CITY OF SWEET HOME PLANNING COMMISSION AGENDA

Planning Commission Staff Report

Staff Report Presented to the Planning Commission

FOOTHILLS RIDGE SUBDIVISION

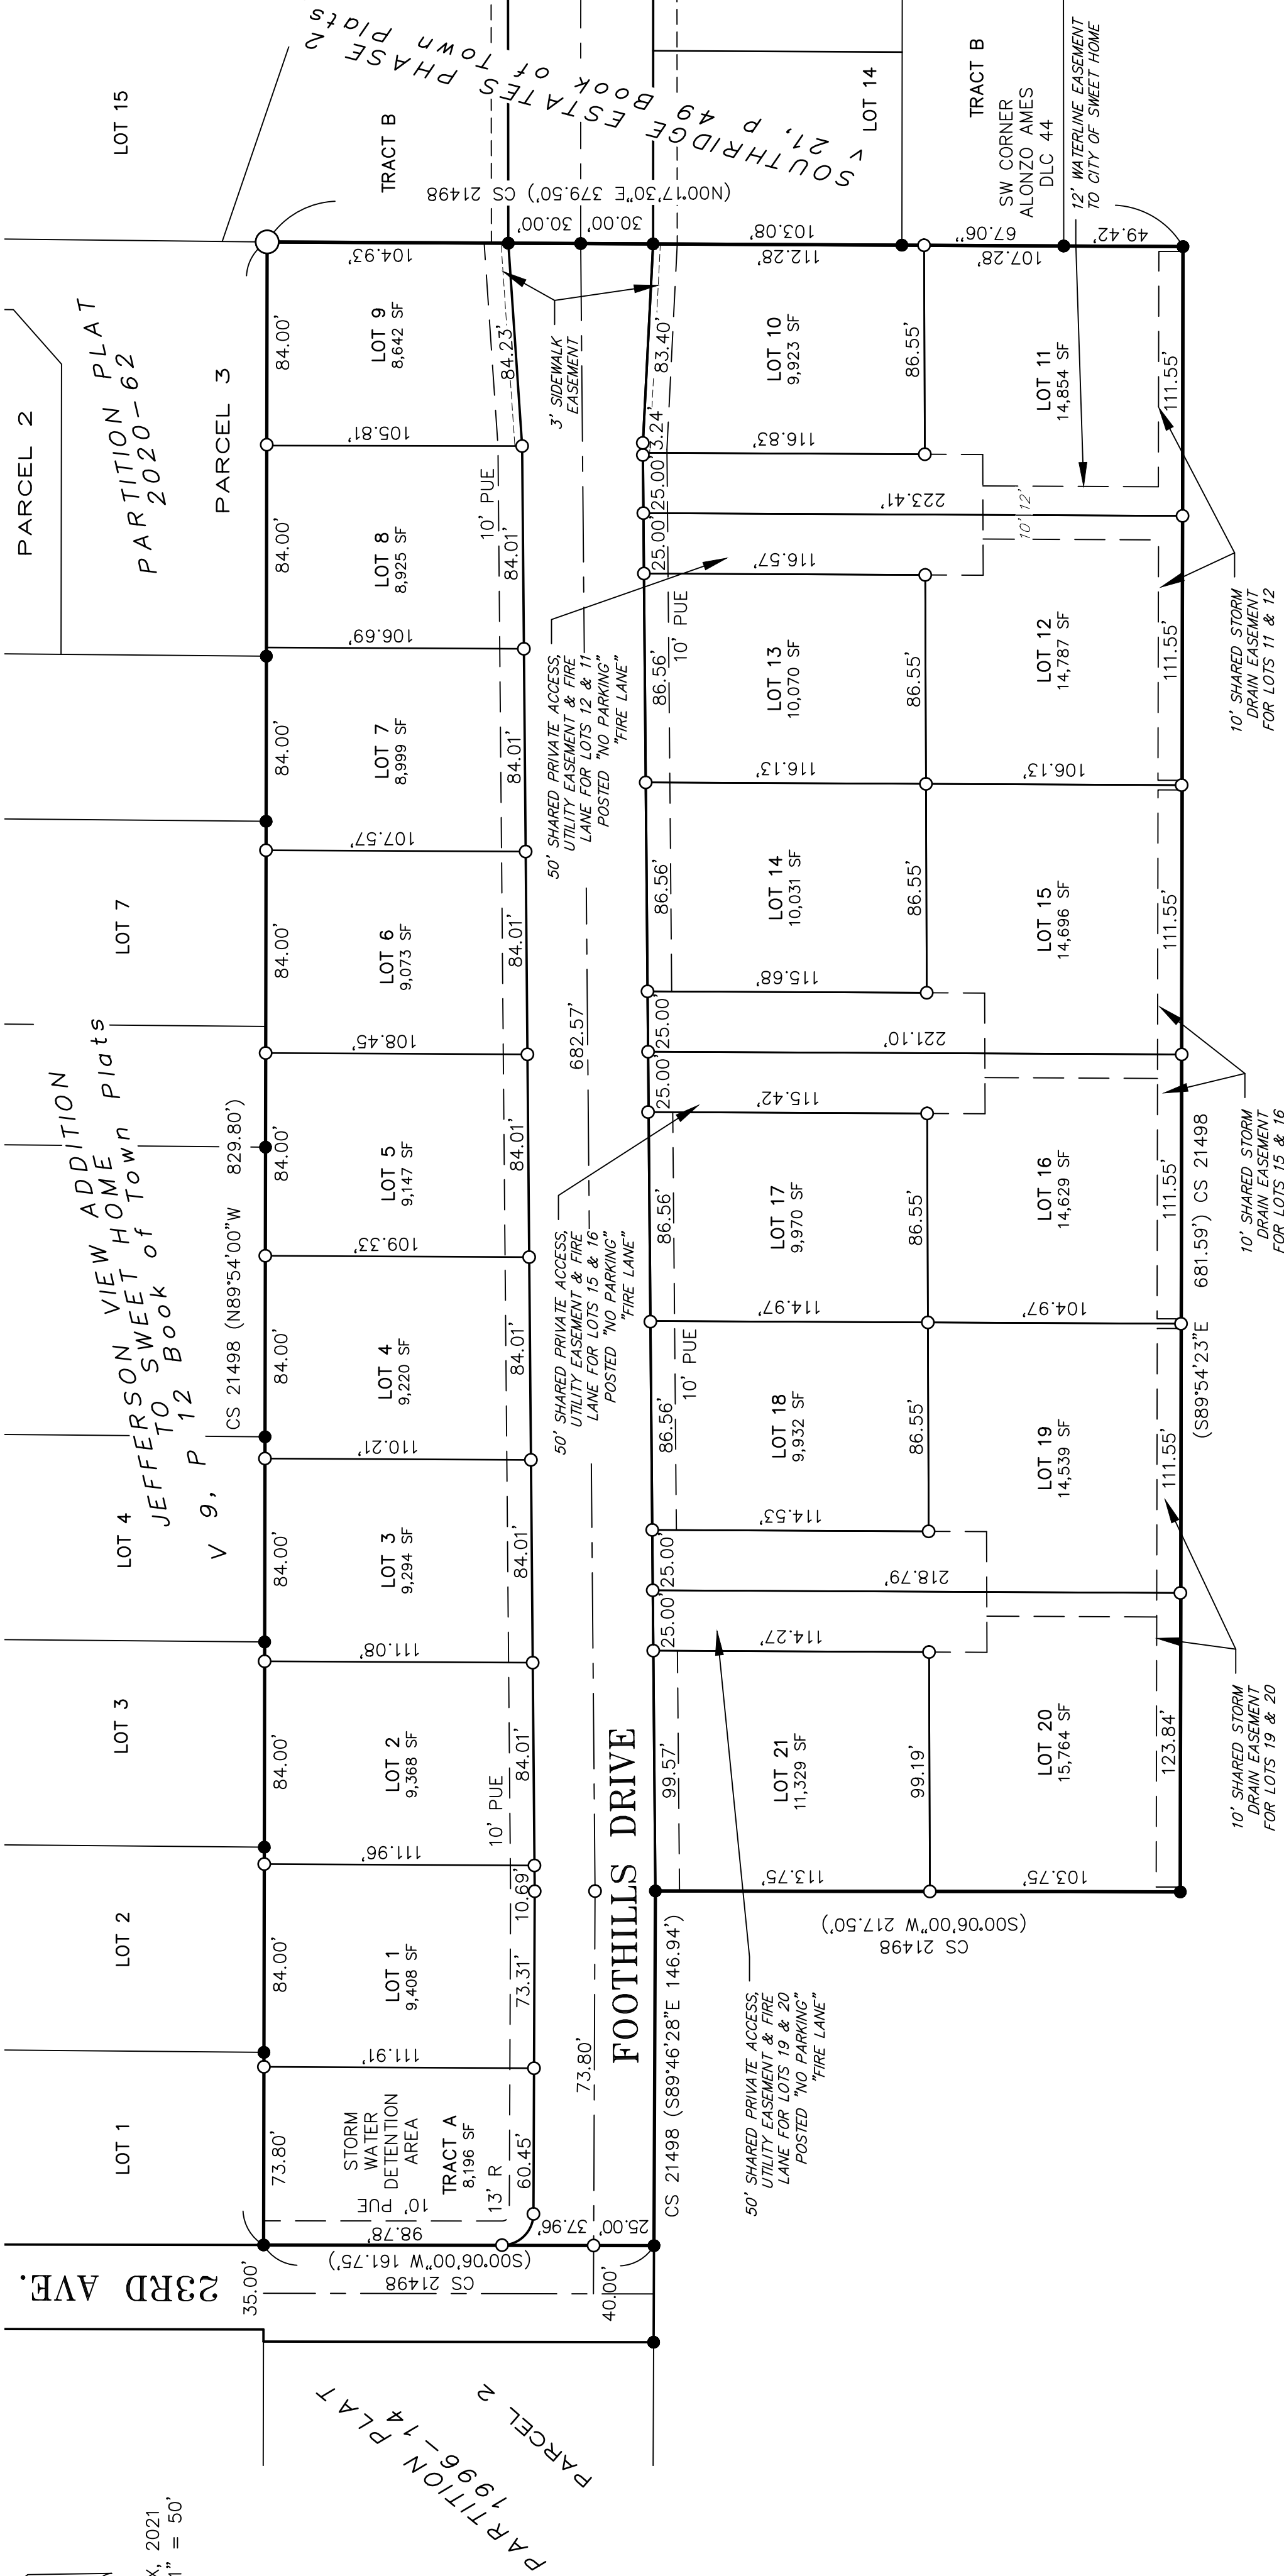
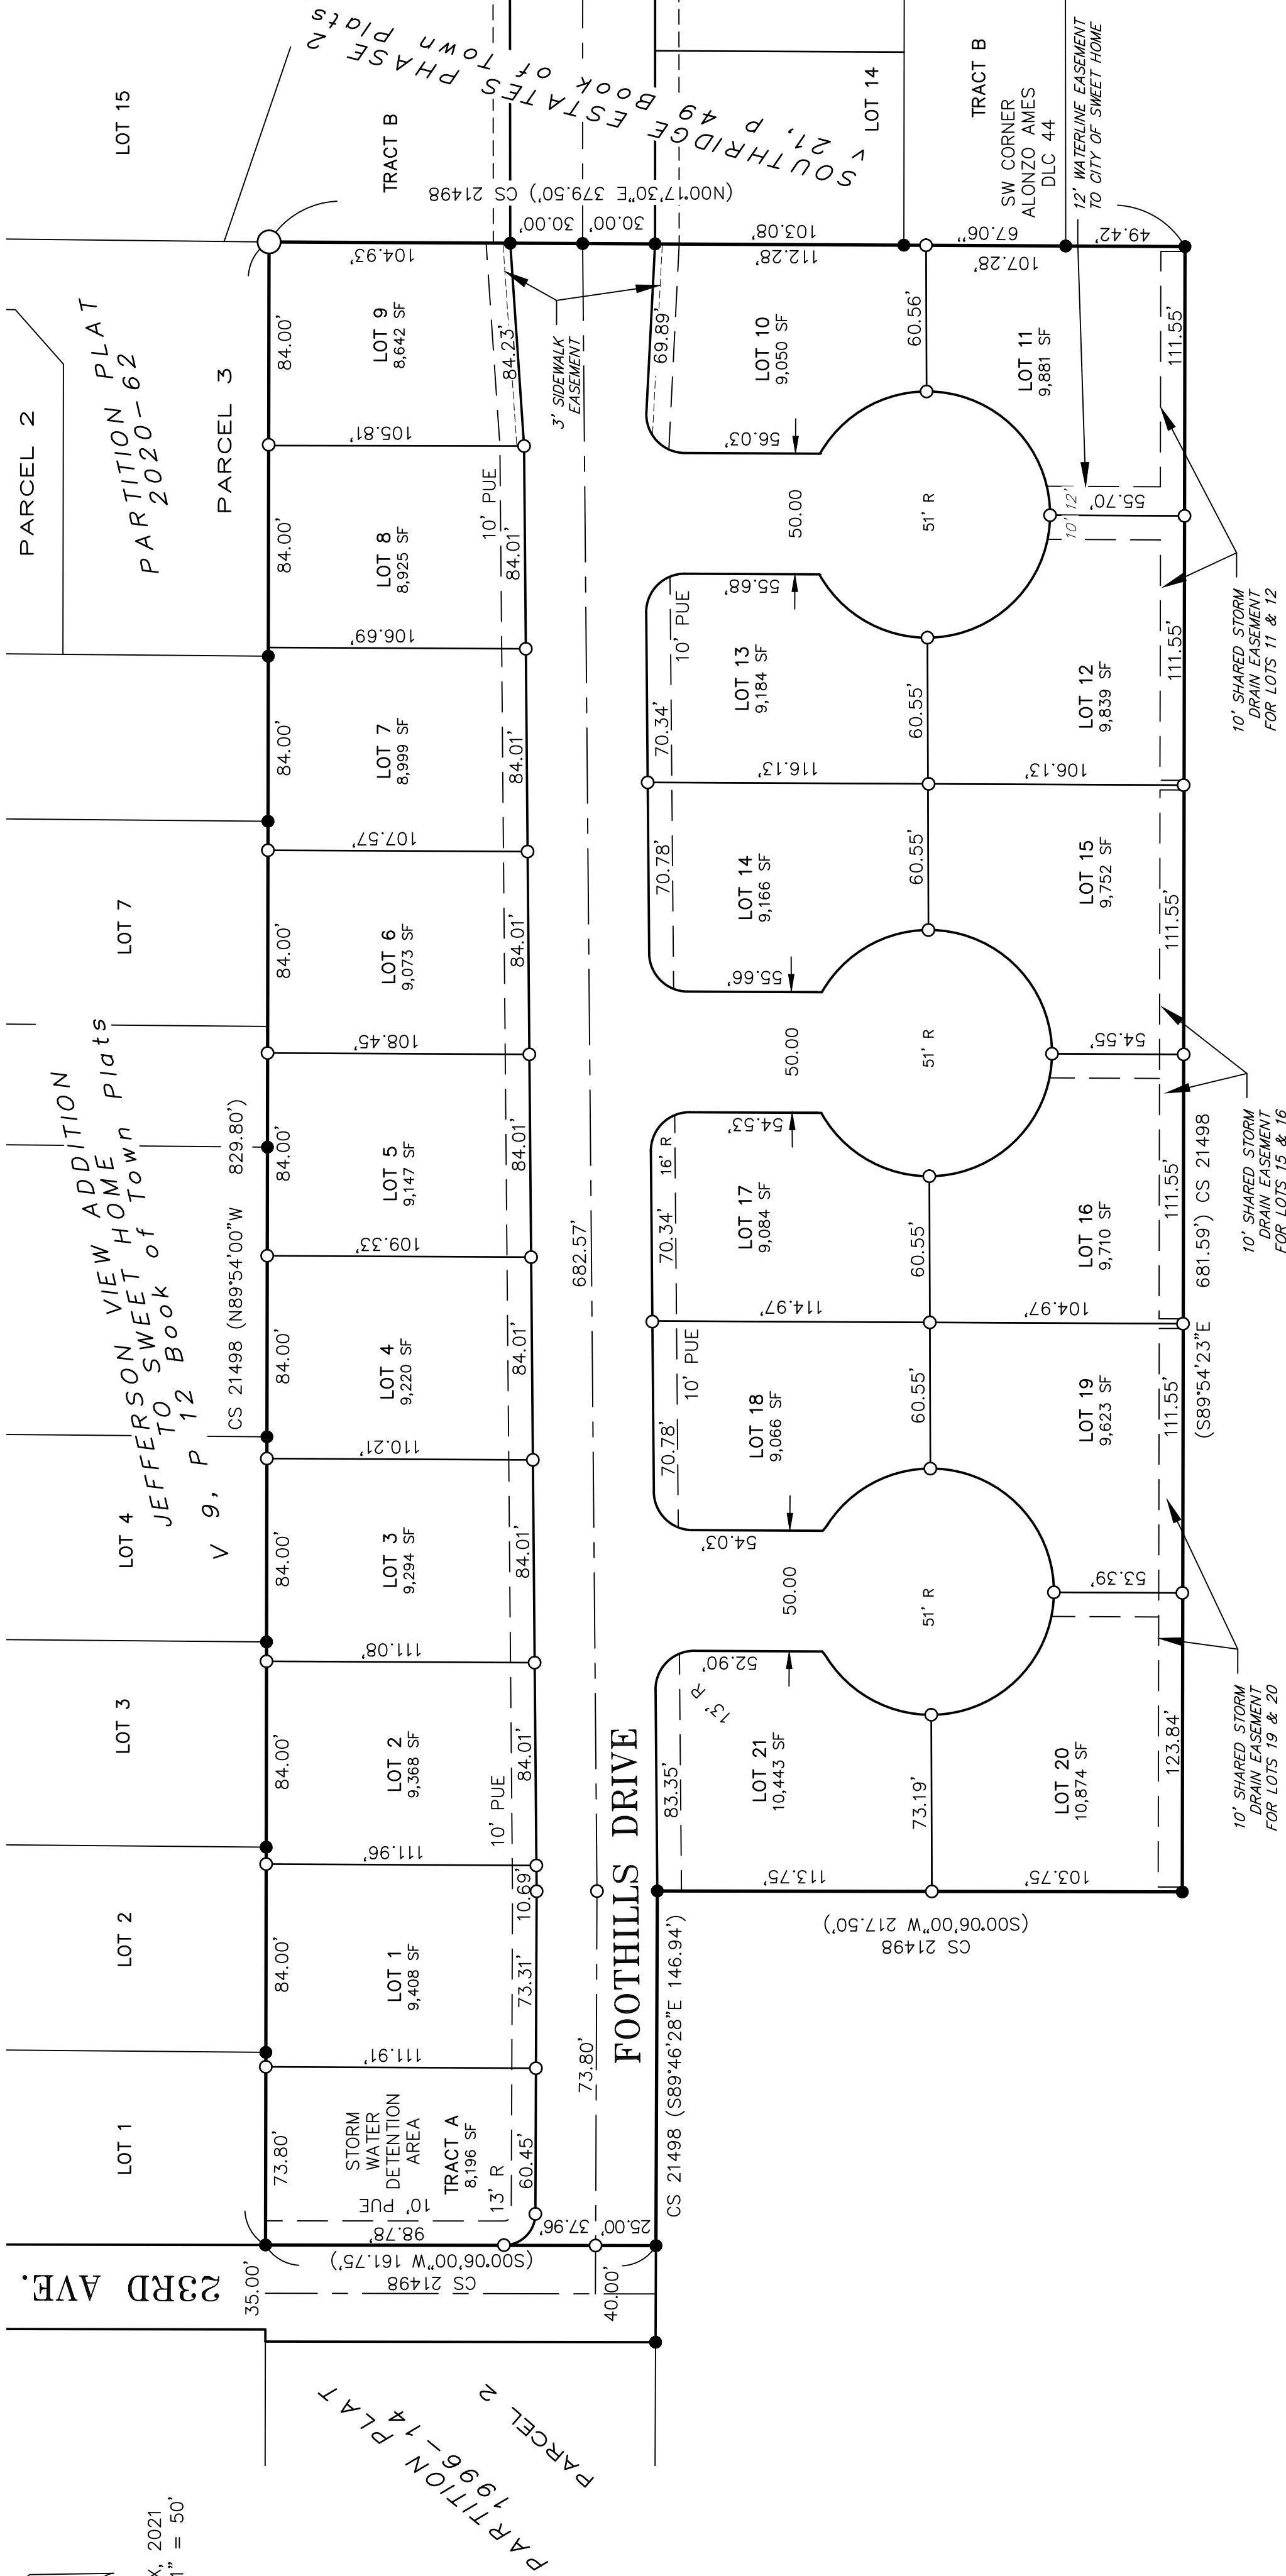
The TSP roadway dimensions require a minimum 3-foot planter strip for Local Streets which the narrative and plan do not show. Foothills Drive is wide enough for planter strips to be constructed and are required. The proposal shows a 50-foot right-of-way, which provides adequate width for 5 feet sidewalk, 4 feet planter, and 30-foot curb to curb widths which provides the minimum 7 feet parking and travel lanes, etc. However, 23rd Avenue is only 40 feet wide with some portions at 35-foot-wide, the planter strips are not required, and sidewalks can be curbside.

The City of Sweet Home wants to have provision for a waterline easement in the common driveway are serving Lots 24 and 25 on Lots 10 and 11. The easement would be the same size as the proposed shared utility and access easements as noted on the Plan Option B. The easement would run from the south right-of-way line of Foothills Drive to the south line of Lots 24 and 25. The City is looking forward 15-20 years to a need for an additional water reservoir in the area, with the adjacent property to the south at the right elevation and location. It has access from Ames Creek road, so that only a waterline would be connected through the lots. We would likely place a conduit in the ground at the time of construction to feed the future waterline through, without the need for excavation at that future time.

The tentative plan does not show how the development will accommodate runoff from the south hillside. There will need to be an easement, channel, area catch basins or some combination of those along the south line of the properties. That stormwater collection will then be another pipeline in the shared driveway easement down the driveway to Foothills Drive. The southern properties are about 12 foot to 15 foot above the central flat portion of the development.

The plan indicates a curb and sidewalk along the east side of 23rd Avenue. That would be a "half street" which is really a "3/4 street" on the ground, comprised of sidewalk, curb and drainage, pavement to the centerline and the opposite lane. There will need to be curb on that side too because residents will travel to and from the subdivision in both directions on 23rd Ave. Because of the very poor condition of 23rd Avenue, and it being the most direct path westward to the community, the improvements on 23rd Avenue need to extend to Harding Street. The City may be able to partner with the developer to improve the street network at 23rd Ave and Harding Street. The city is currently looking to overlay both streets, so by the time this proposed subdivision starts construction, there may already be good pavement in portions of 23rd Ave and Harding Street.

The indicated proposed mainline sewer systems appears to be able to provide each lot with service. For the properties on the south boundary that appear to be sharing the driveway accesses, each lot will have its own sewer lateral line.

1. The final configuration of the proposed lots shall substantially conform to the plot plan reviewed in this application. See Attachment B. The final configuration is to subdivide an approximately 6.50-acre property into twenty-six lots ranging from approximately 8,226 to approximately 9,950 square feet. The proposed subdivision's average lot size is approximately 8,932 square feet. Approximately 8,226 square feet shall be reserved for a storm water detention area. Approximately 4,373 square feet shall be dedicated as public right-of-way for an extension of Foothills Drive to serve the proposed subdivision.

2. The applicant shall provide a waterline easement through Lots 10, 11, 24 and 25 in the common driveway that serves Lots 24 and 25. The easement would be the same size as the proposed shared utility and access easements as noted on the attached site plan (Attachment B). The easement would run from the south right-of-way line of Foothills Drive to the south line of Lots 24 and 25.

6. The applicant shall provide an easement on adjacent Lot 1 (751 23rd Avenue) to provide a connection to the storm water detention area.
7. The applicant shall provide stormwater collection easement along Lots 18-25 to accommodate the run-off from the south hillside. The storm water collection will be through the utility easements to Foothills Drive.

9. The applicant shall provide each lot with its own sewer lateral line.
10. Within one year from date of the approval of the tentative plan, the applicant shall prepare a final plat in conformance with the approved tentative plan, the provisions of this title and the provisions of O. R. S. Chapter 92. The applicant shall submit a final subdivision plat for approval by the City according to the procedures and requirements of SHMC 16.20. The applicant shall provide all information required by SHMC 16.20.
